Wabco Hydraulic Brake Modulator Motor Cover Drain

BULLETIN

Models Affected: All American, Vision Models Equipped with Hydraulic Brakes

S I O S G

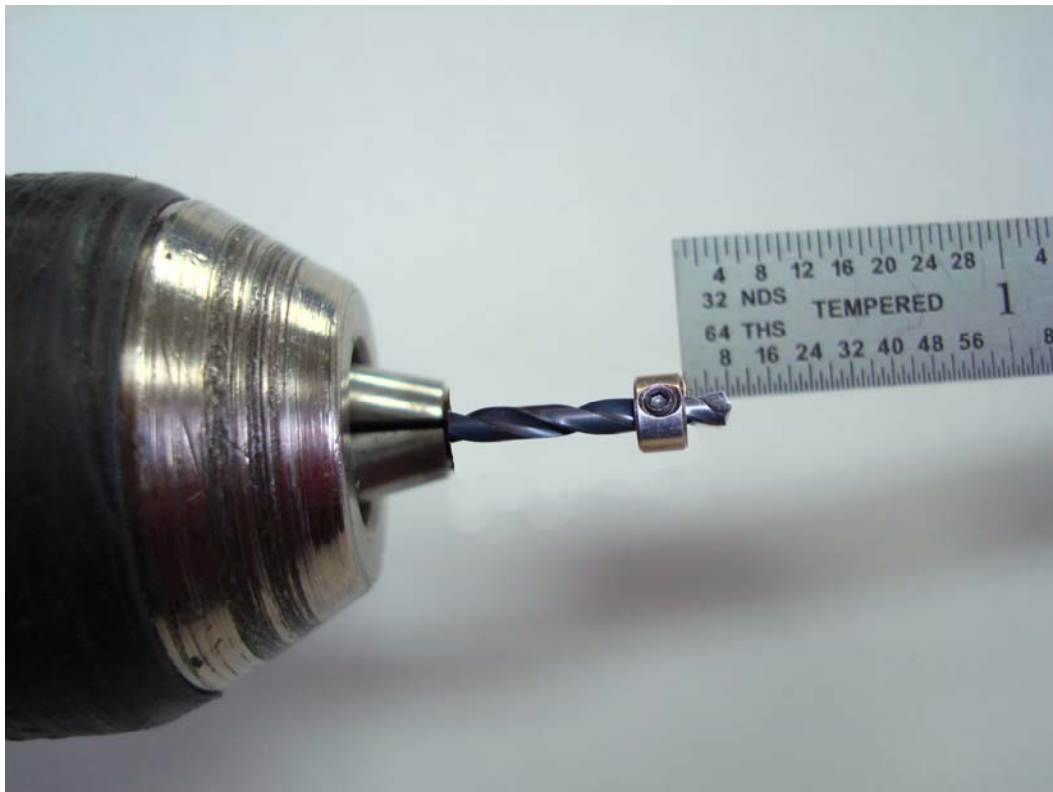
The Wabco hydraulic brake modulator motor cover may fill up with water and corrode motor.

Drill a 3/32" drain hole in bottom of cover to allow for drainage.

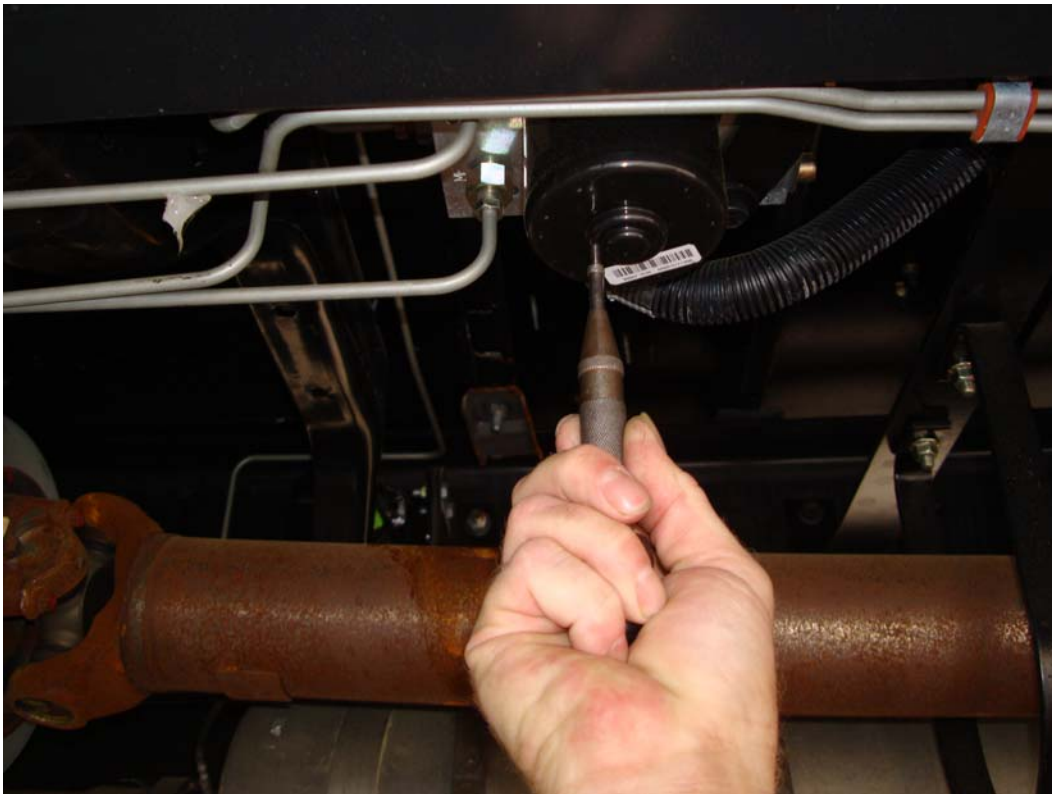
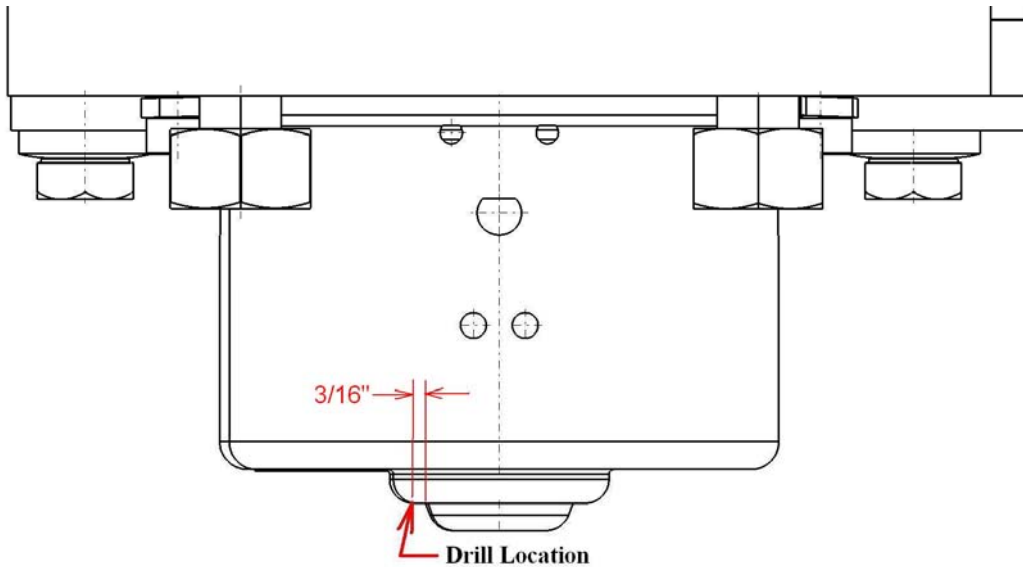
3. Hydraulic modulator is located under the bus, between the frame rails, on the driver's side. Use a center punch at the location shown below to set the drill location.

Caution: *Drilling in any other location may cause damage to motor.*

- Carefully drill a 3/32" diameter hole 1/8" deep into the cover.

Caution: Drilling deeper than 1/8th inch may cause damage to motor.

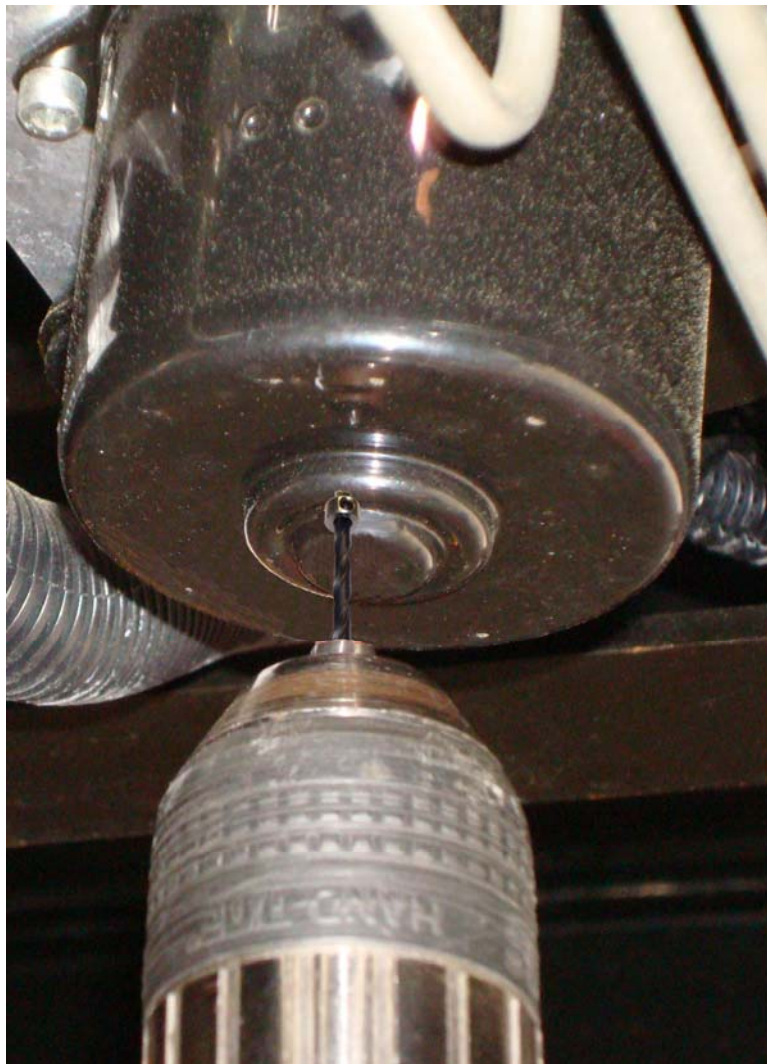
Warning: To prevent electrical shock and/or injury, use a cordless drill or an air powered drill to perform this task. Water may leak from cover when drill bit has penetrated thru the cover material.

Caution: When drilling overhead, wear protective eye wear and appropriate clothing for protection during drilling operation.
